DESIGN REVIEW REPORT AND DECISION

File Number: DSRFY2026 - 0003

Review Status: APPROVED AS CONDITIONED

- 1) Owner:** LOTS OF LAND LLC
- 2) Street Address:** 212 W 41ST ST GARDEN CITY
- 3) Ada County Tax Parcel Number(s):** R2734510560
- 4) Property Description:** LOTS 9-11 INC EXC DEED TO ADA CO FOR R/W BLK E FAIRVIEW ACRES SUB 2 #8860243

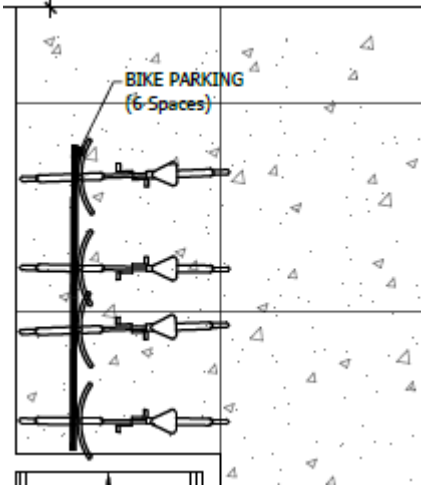
The first floor shows 4 bikes, but the note indicates 6 spaces.

The site plan shows 6 spaces

10. There shall be a minimum of 57 bicycle parking spaces provided; with 48 to be covered.
 - a. Bicycle parking spaces assigned to individual units shall be clearly dimensioned on the floor plans.

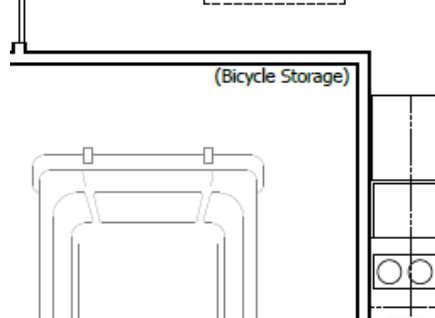
All garages on the first-floor show bike storage signs.

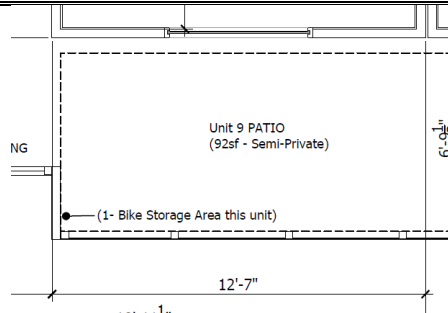
On the semi-private balcony of each side unit, a sign indicates a single bike parking space.

Total for 12-plex: 14 parking spaces

18 plex:

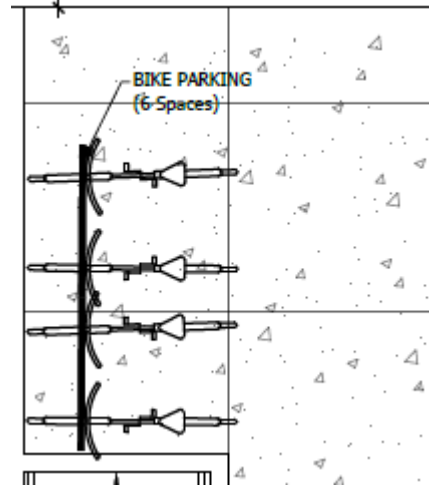
The first floor shows 4 bikes, but the note indicates 6 spaces.

All garages on the first-floor show bike storage signs.

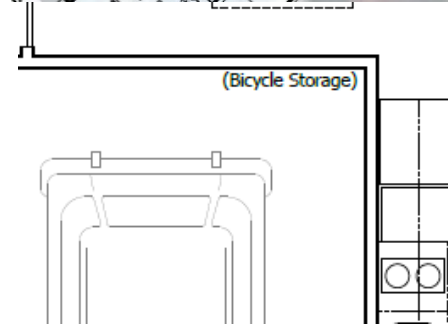
The site plan shows 6 spaces

Total for 18-plex: 12

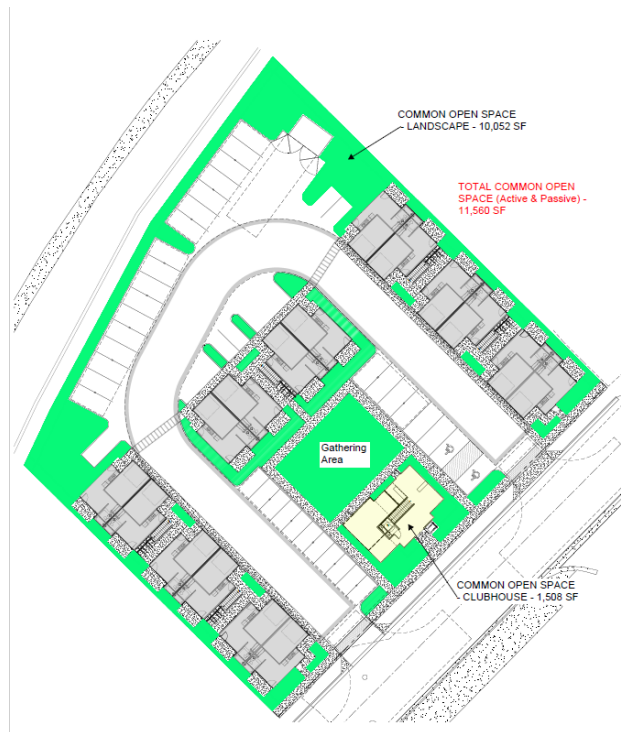
A landscape buffer with a minimum of eight feet between the street and sidewalk and 78 feet in linear distance with required street trees and seating;

The applicant provided an updated site plan dated 05/14/2026 showing an 8-foot green buffer area between 41st Street and the sidewalk. The length of the area is approximately 228 LF. Excluding the two driveways, the square footage of this area is approximately 1,440 SF.

18. A minimum of two hundred fifty (250) square feet of common open space shall be provided for each unit.
 - a. The applicant shall provide a minimum of 11,514 square feet of common open space.

- i. This amount reflects a reduction of 486 square feet, based on the dedication of 1,945 square feet of public open space west of the clubhouse.
 - ii. Prior to issuance of a certificate of occupancy, the applicant shall execute and record a public access easement over the dedicated area, execute any required agreement(s) with the City addressing public access and long-term maintenance, and provide plan notes and on-site signage, as applicable, confirming that the space will remain open and accessible to the public.
